12524 MOORES CHAPEL RD

Mecklenburg County
Health Department

Re: New Subdivision/Moore's Chapel Road, lot 6
File: 3300B
Parcel: 053-174-05

PROPOSED PLOT PLAN

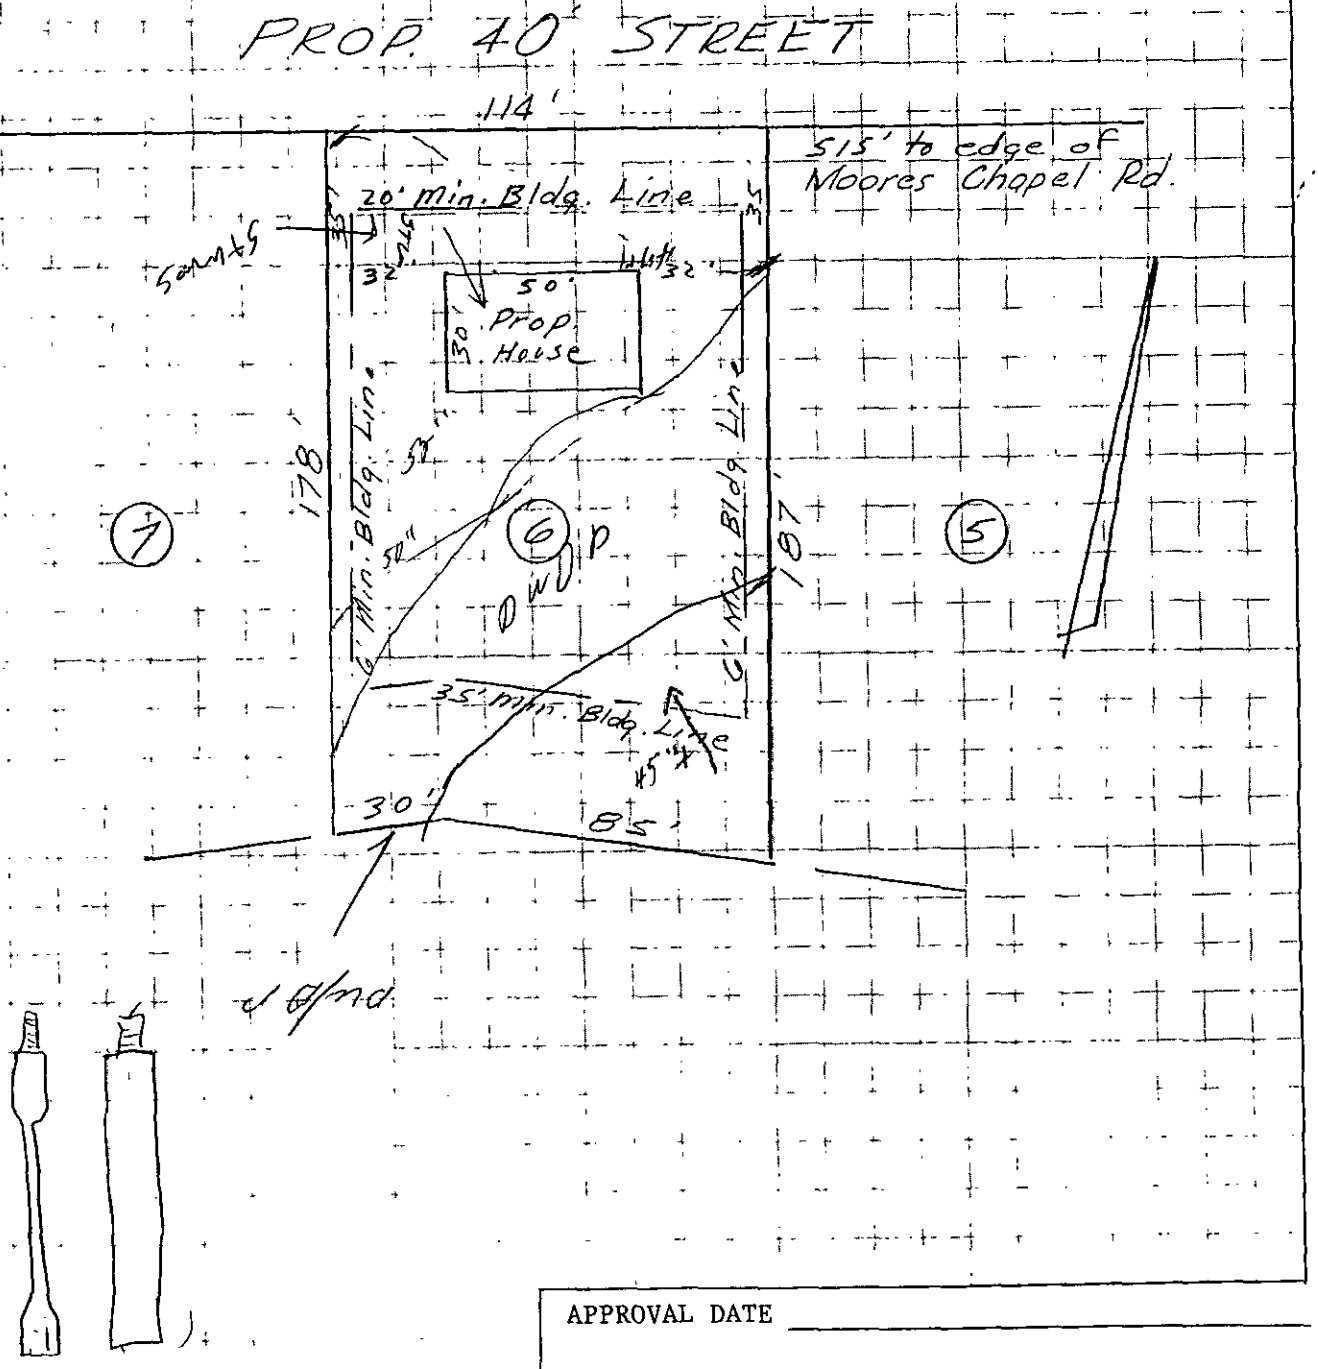
1- The available area on this site is classified as **UNSUITABLE** according to the following rules:

(a) .1940 Topography and Landscape Position
(b) .1945 Available Space

For these reasons, the plans as submitted are disapproved.

Possible ways to develop this site includes submittal of a plan for a Prefabricated, Permeable Block Panel System (PPBPS). These plans would also need to include appropriate surface water diversions. Enclosed is a copy of Rule .1956 Modifications to Septic Tank System pertaining to PPBP Systems.

MECKLENBURG COUNTY HEALTH DEPARTMENT
SITE EVALUATION REPORT
SERIAL NUMBER 20548

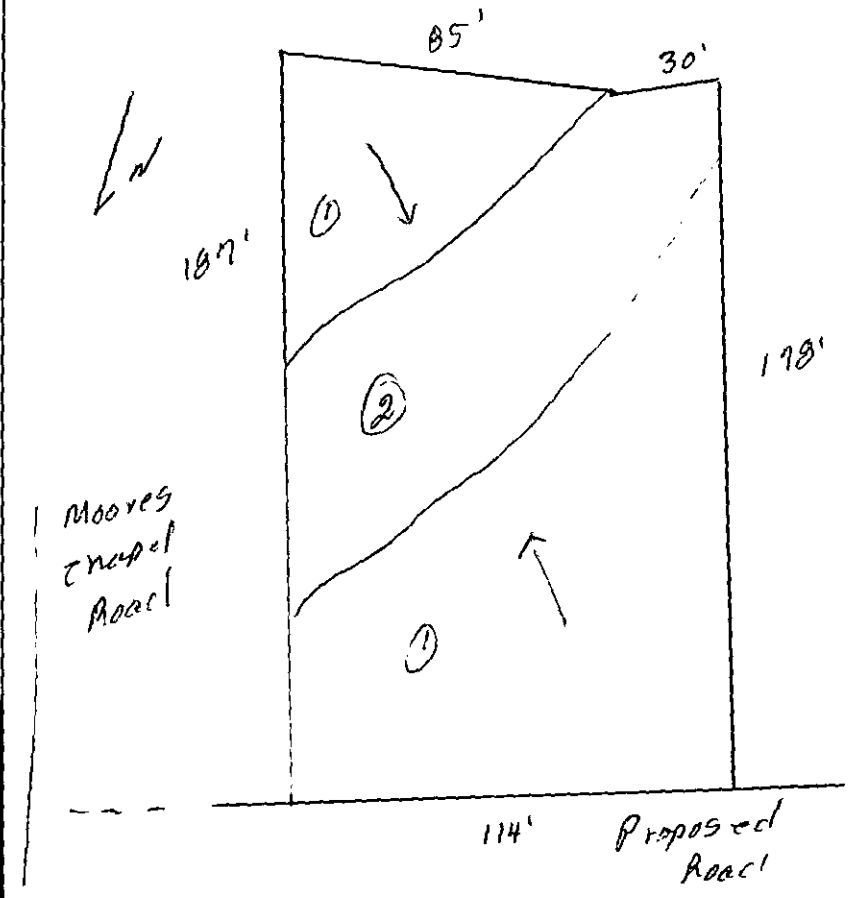
Comments: .3 gal/ft/day LTAR

FACTORS	AREA 1	AREA 2	AREA 3	AREA 4	AREA 5	AREA 6
Topography	(S) PS U 2-10%	S PS (U) Drainageway/Depression	S PS U	S PS U	S PS U	S PS U
Texture	S (PS) U slightly Expansive clay	S PS U —	S PS U	S PS U	S PS U	S PS U
Structure	S (PS) U Subl Blocky	S PS U —	S PS U	S PS U	S PS U	S PS U
Drainage	(S) PS U 7-46" To water	S PS U —	S PS U	S PS U	S PS U	S PS U
Depth	S (PS) U 7-45"	S PS U —	S PS U	S PS U	S PS U	S PS U
Restrictive Horizons	(S) PS U 7-46"	S PS U —	S PS U	S PS U	S PS U	S PS U
Available Space	S PS (U) Restricted	S PS U —	S PS U	S PS U	S PS U	S PS U
Other (specify)	S PS U	S PS U	S PS U	S PS U	S PS U	S PS U
Soil Group/Series	IV CcC: Lo	Drainageway/ Depression				
Area Classification	S PS (U)	S PS (U)	S PS U	S PS U	S PS U	S PS U
